STATE OF MAINE
DEPARTMENT OF TRANSPORTATION
16 STATE HOUSE STATION
AUGUSTA, MAINE
04333-0016

September 19, 2006
Subject: **Rockland**
Project No. BH-6069(20) & 6069.40
Pin No. 6069.20 & 6069.40
Amendment No. 3

STATE OF MAINE
DEPARTMENT OF TRANSPORTATION
ROCKLAND FERRY TERMINAL
P.I.N. NO. 006069.20

HOIST REEVING DIAGRAM

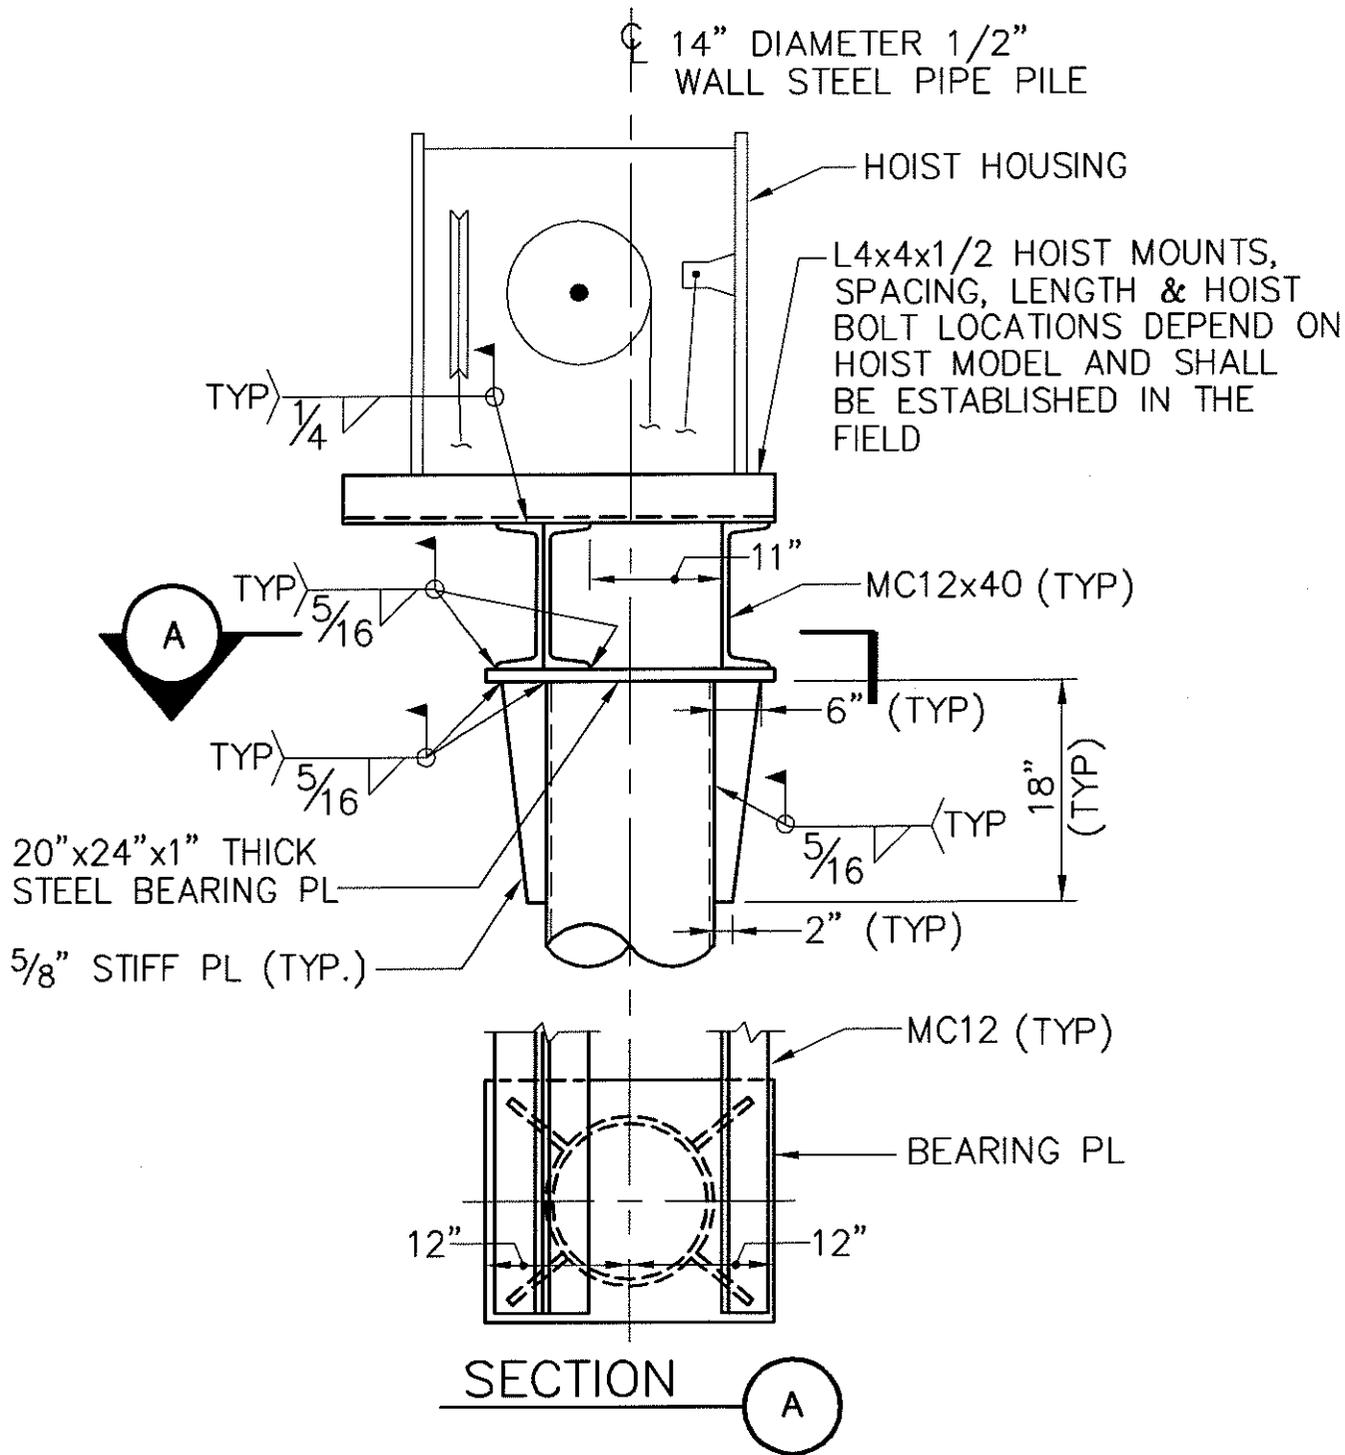
Under “NOTES”, at the lower right side of the sheet, after note number six add the following note: “7. For Hoist Reeving Diagram See Sheet S11.” Make these changes in pen and ink.

On Sheet S11/page eighteen of sixty-three titled: ” Matinicus Transfer Bridge Details – Part 2” at the lower right side of the sheet INSERT the “Hoist Reeving Diagram” on the attached SKETCH – 2 drawing dated September 13, 2006.

Question: The Matinicus Transfer Bridge drawing on sheet S9 shows a straight line pull from a 35 ton hoist to the upper hoist beam. The special provision Section 532.04 item number 7 seems to indicate reeving is necessary. There is also no mention of 35 ton capacity in the special provision. If reeving is necessary what is the design concept for this? Also could you confirm the operating load criteria and range of motion of the bridge?

Response: See earlier changes in this amendment to Section 532.
